The Carlisle 3600 Central SE

Traffic Circulation Layout

Engineer's/Architect's Stamp dated 11-11-15 (K17-D069)

**C-102** TCL Plan 1 OF 2

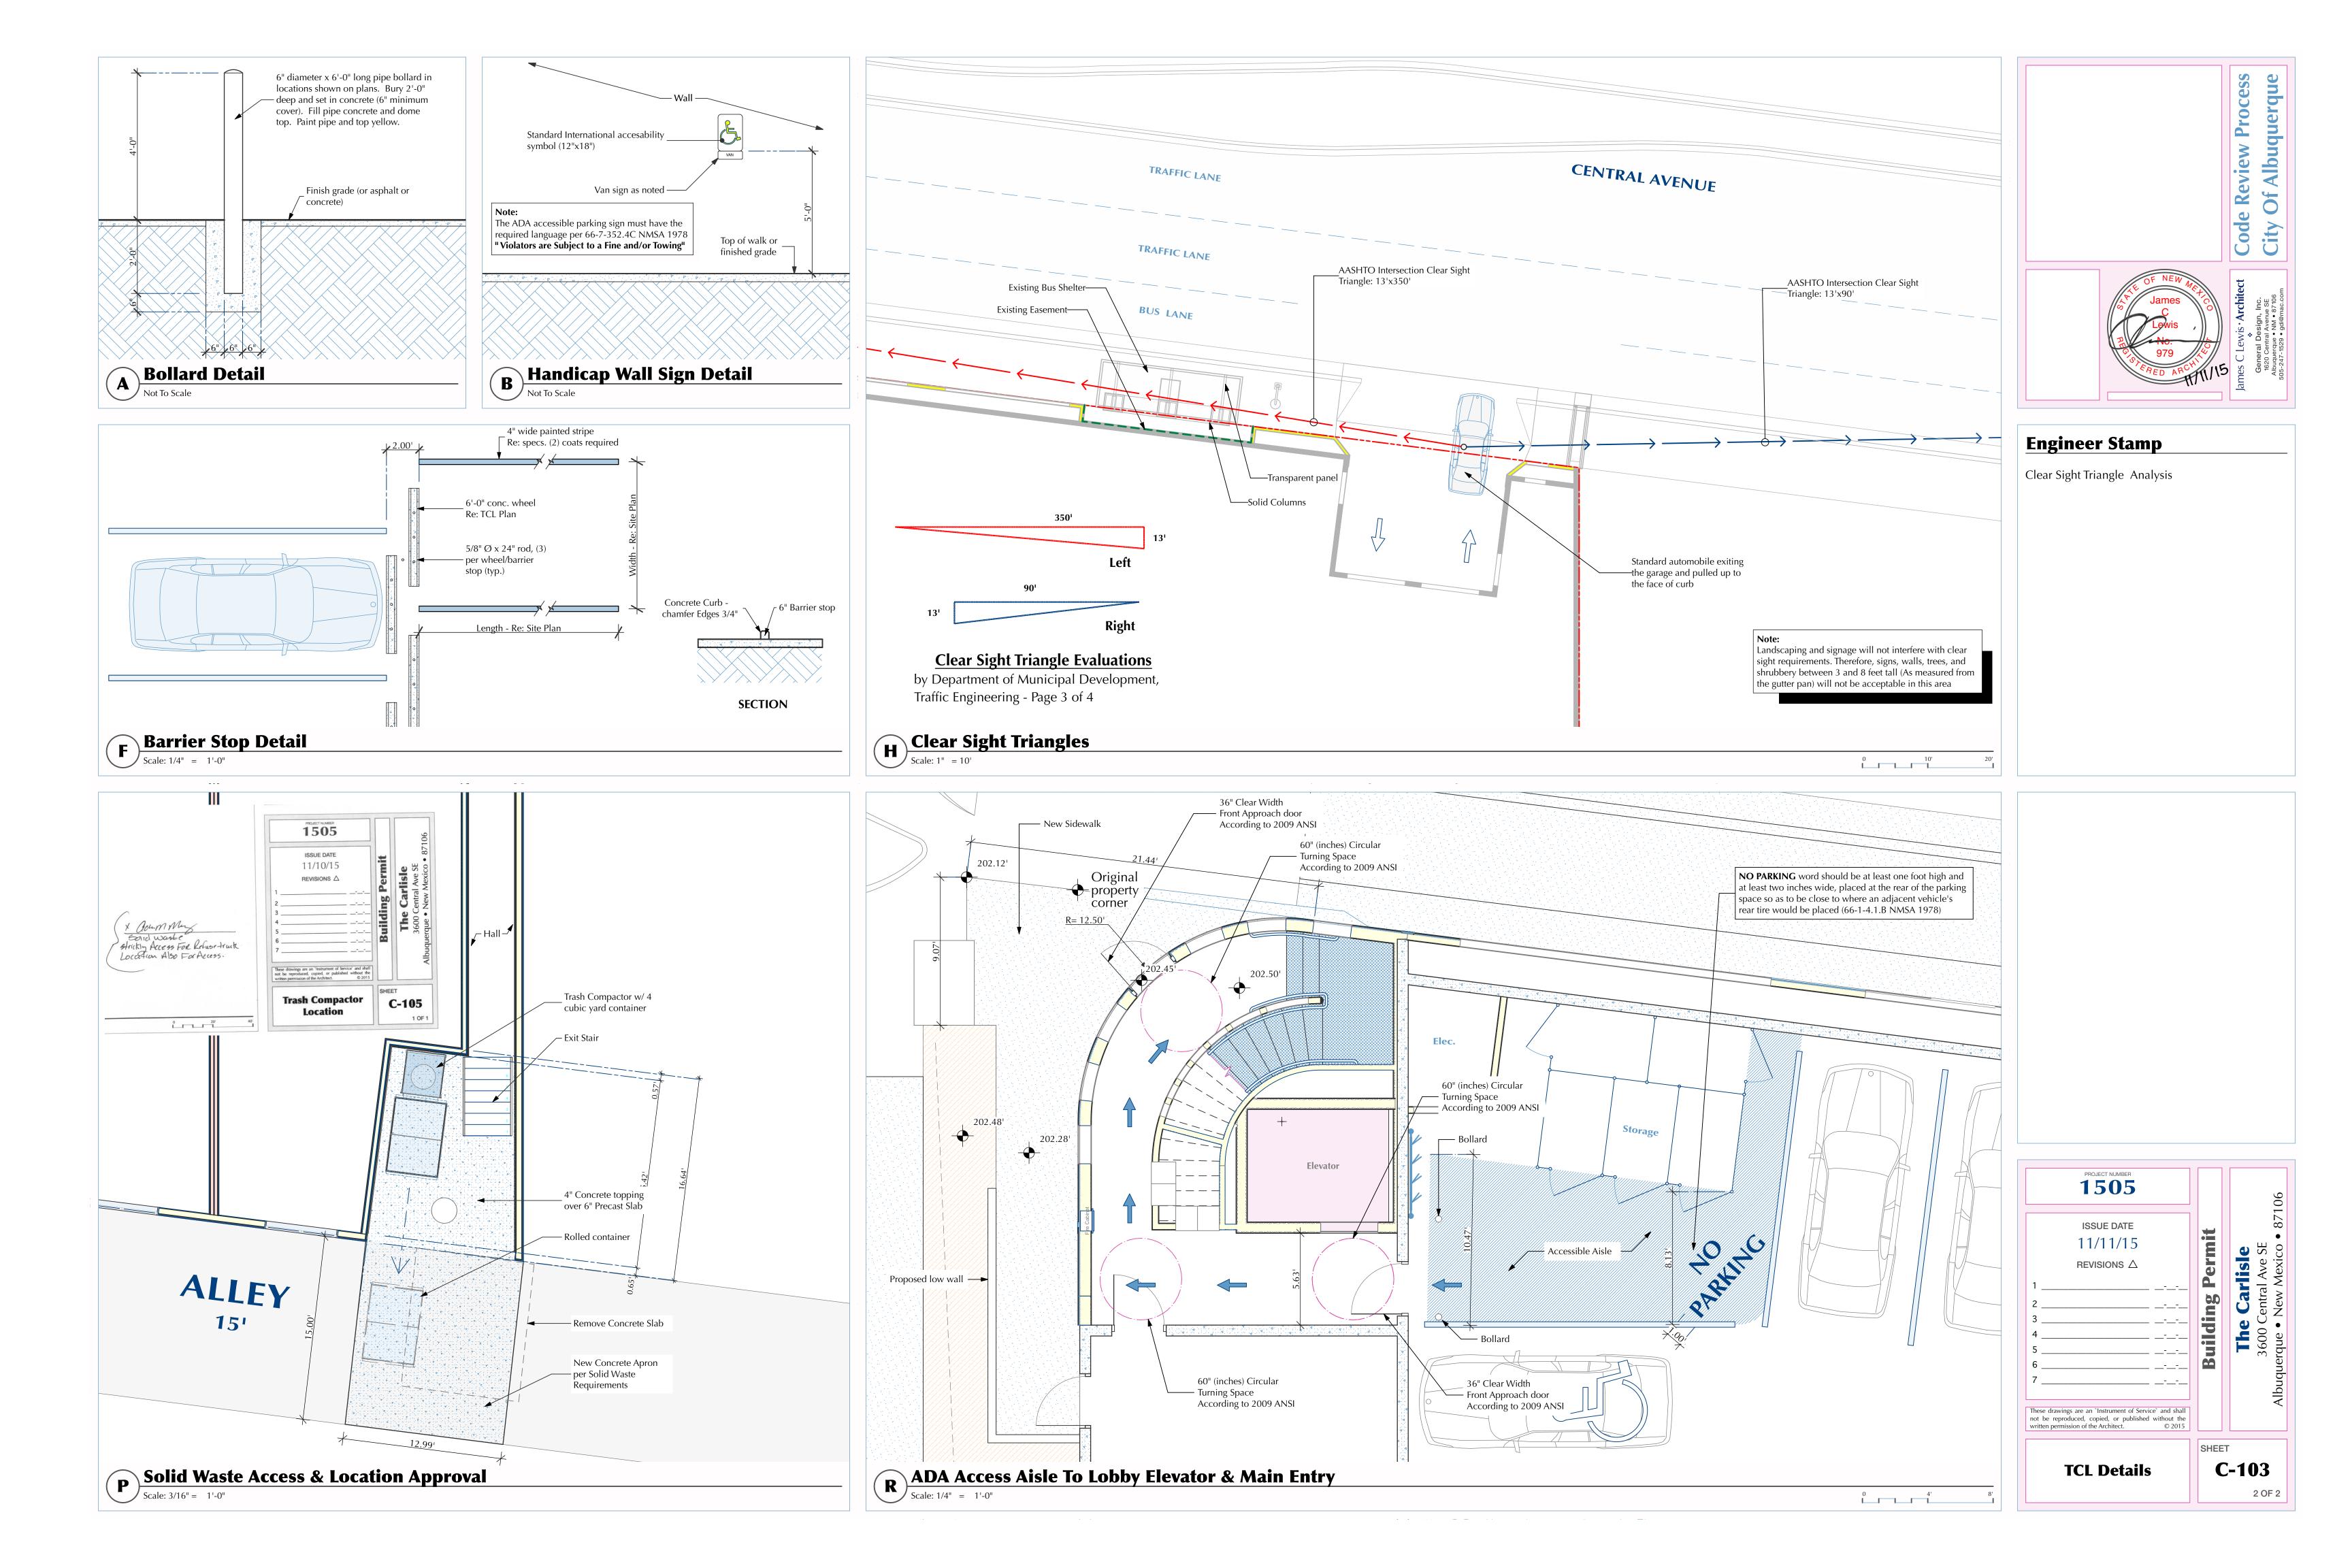
- 1. Upon review, the development project does not meet the Clear Sight requirements.
- 2. Please include two copies of the traffic circulation layout at the next submittal.
